Determination 2008/96

Whether proposed building work complies with the fire safety requirements of the Building Code in a multi-sport complex at 20 Wayland Street, Gore

Figure 1: Isometric view of the multi-sport complex

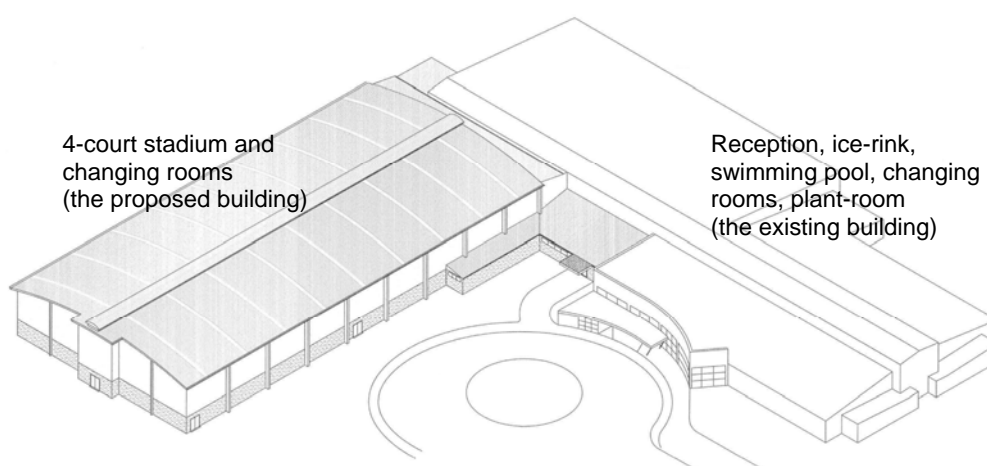
- 2.1 The proposed building, which is now largely complete, is one part of a multi-sports complex. The proposed building contains a four-court stadium and changing rooms. It is located at right angles and attached to an existing building which is part of the same complex. The existing building contains a reception foyer, changing facilities, an ice-rink, a swimming pool, and a plantroom. The complex is shown in Figure 1.
